Reference: 21.519r04v03

Re: **12-20 Berry Road & 11-19 Holdsworth Avenue, St Leonards
Proposed Residential Flat Building Development (DA115/2022)
RFI Traffic Responses**

Swept Path Analysis
Service Vehicle Bays
B99 Vehicle
Left Space

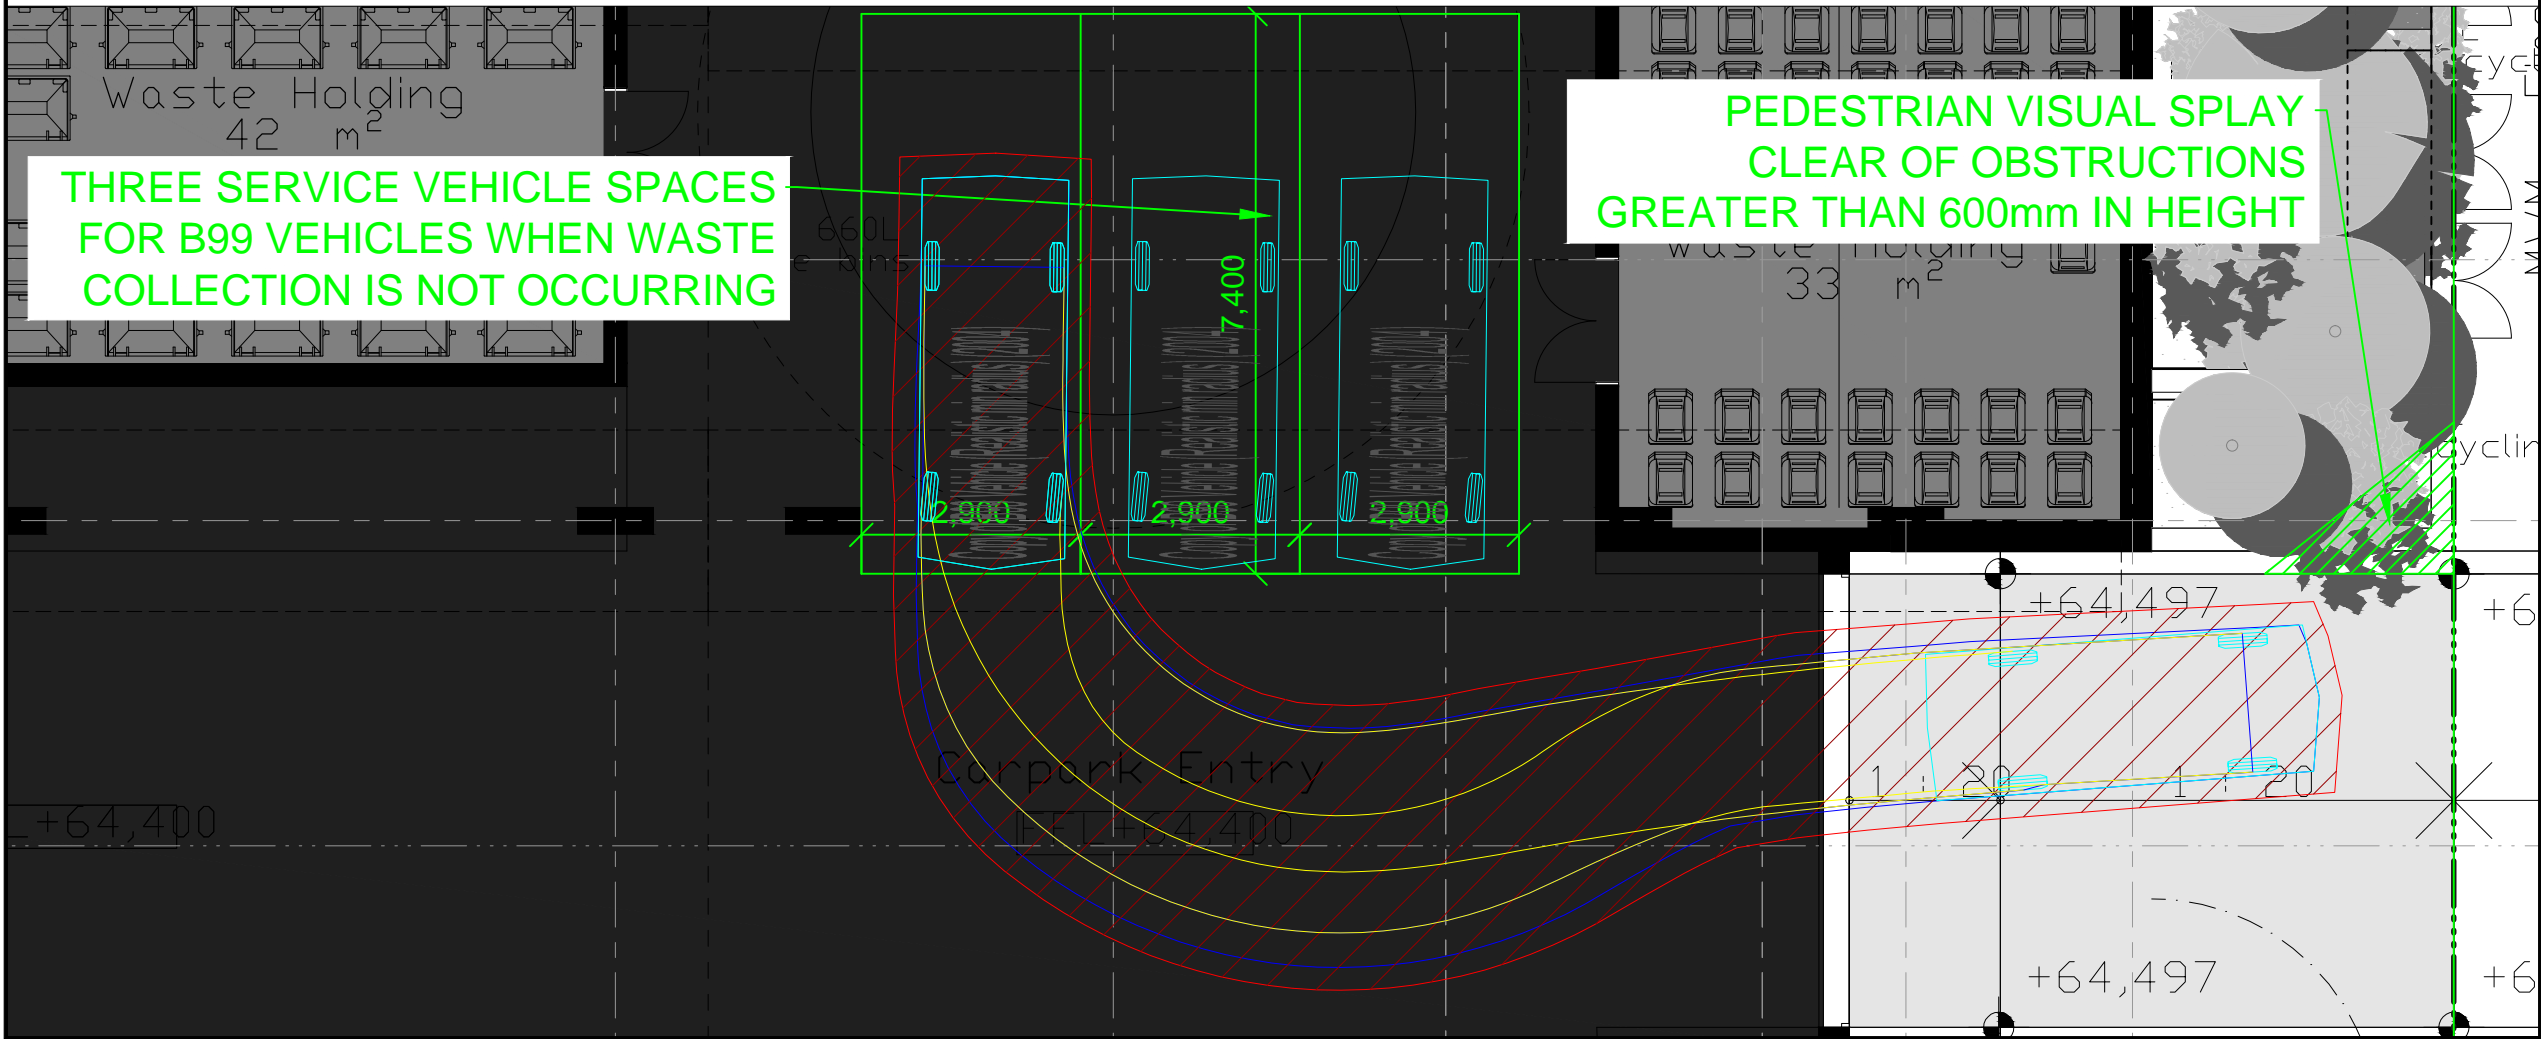
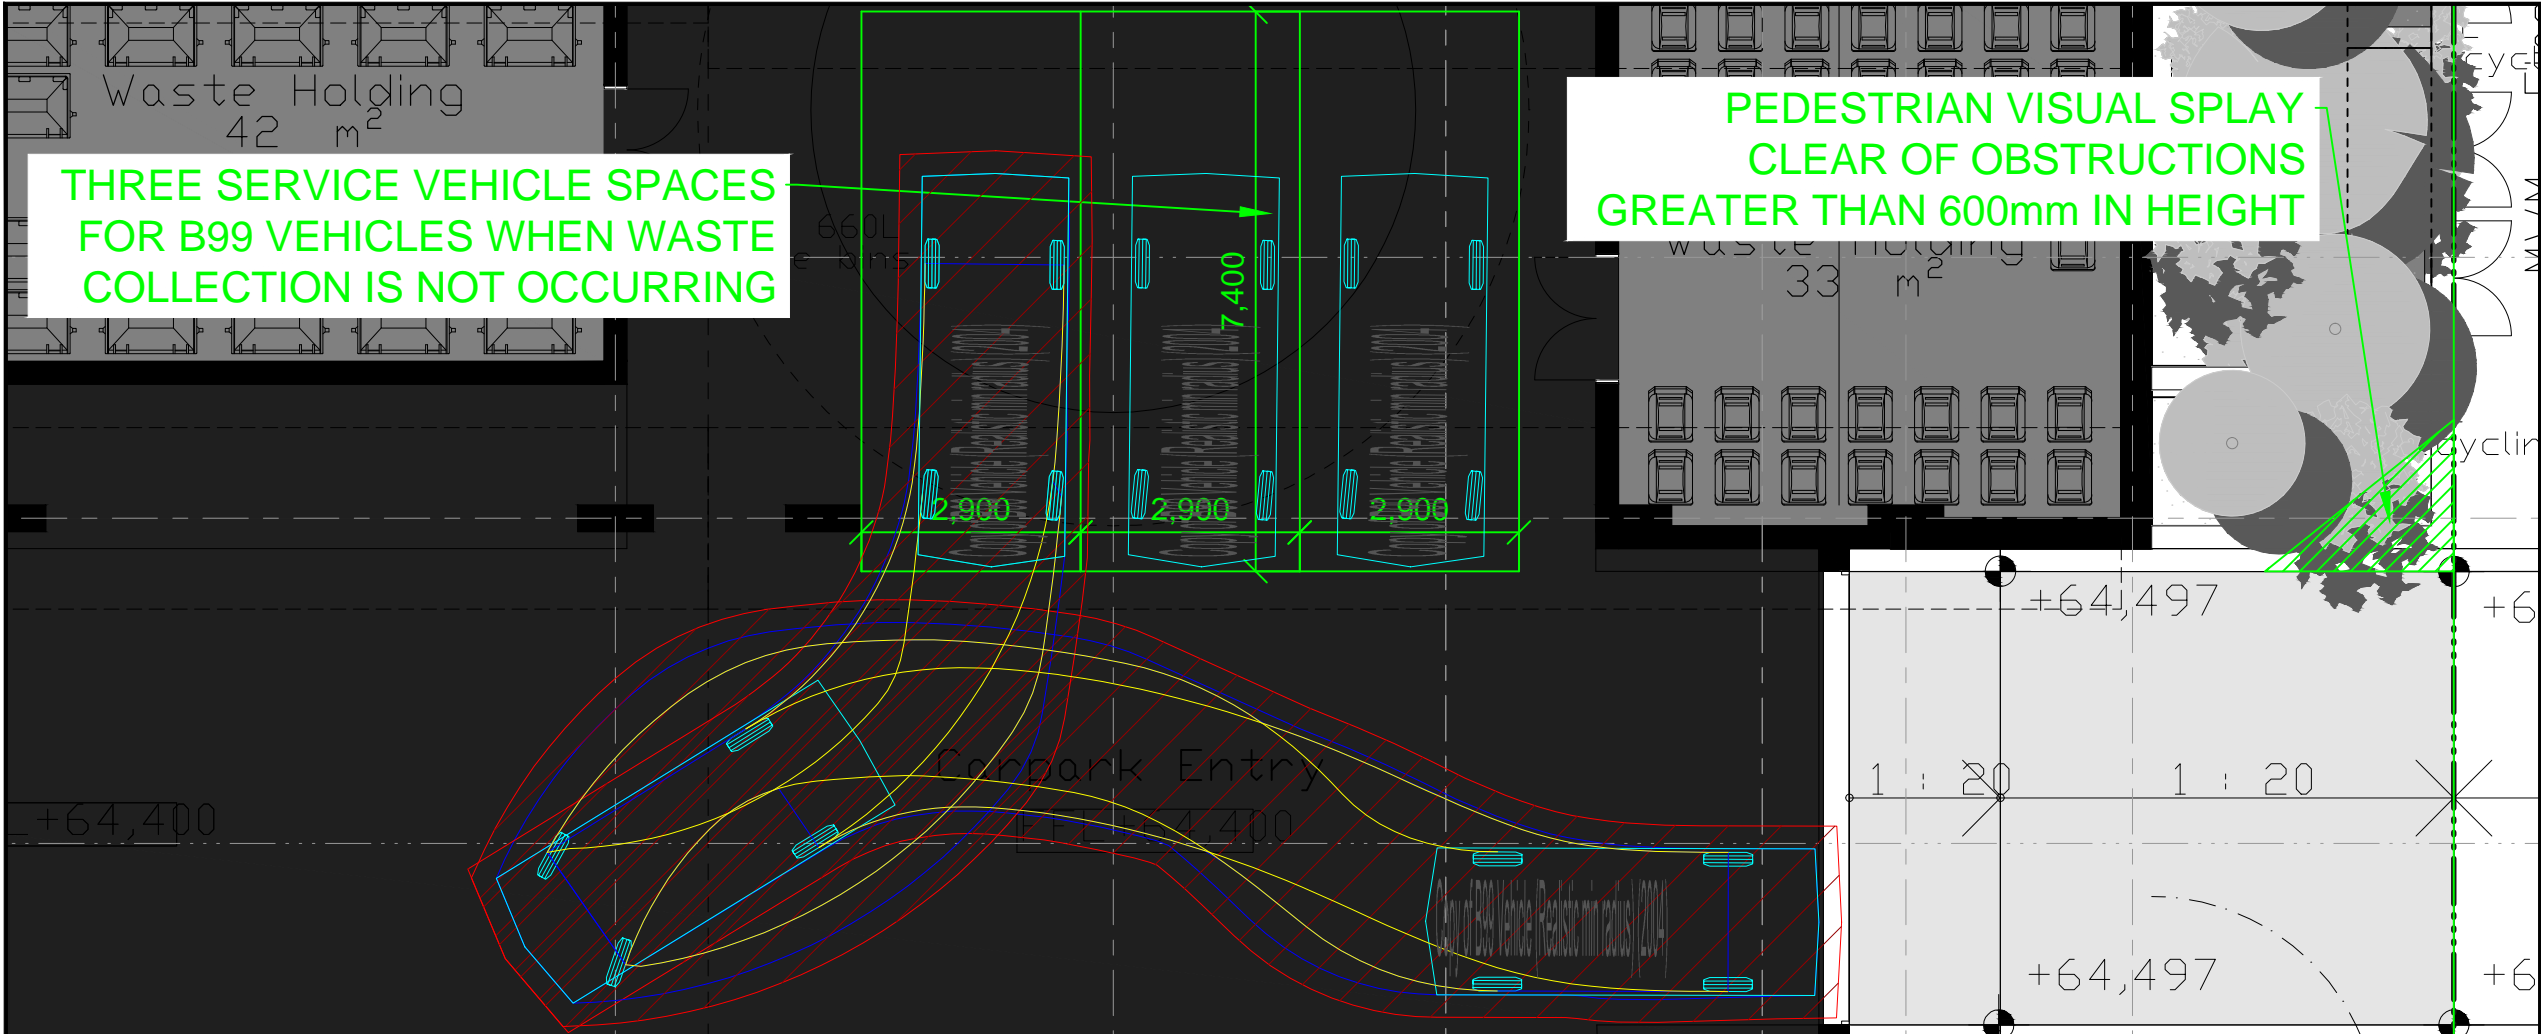
- *Provide swept paths on how three Service Vehicles can occupy the proposed Service Area*

Table 2 of Part R of the Lane Cove DCP requires residential developments to provide 1 service bay per 100 residential units. Application of this rate to the proposed 130 units results in a requirement of 1.3 or a single service bay. As such, the proposed development complies with Council requirement. Nevertheless, the service area has been designed to also accommodate up to three (3) B99 vehicles (vans, utes, couriers etc.), and as such, provides above the minimum DCP requirements. It is noted that a detailed Loading Dock Management Plan could be prepared in response to a suitable condition of consent to manage waste /recycling collection, trades/couriers and removalist vehicles. Swept path analysis presented in Attachment 1, demonstrates satisfactory access three (3) B99 service vehicles.
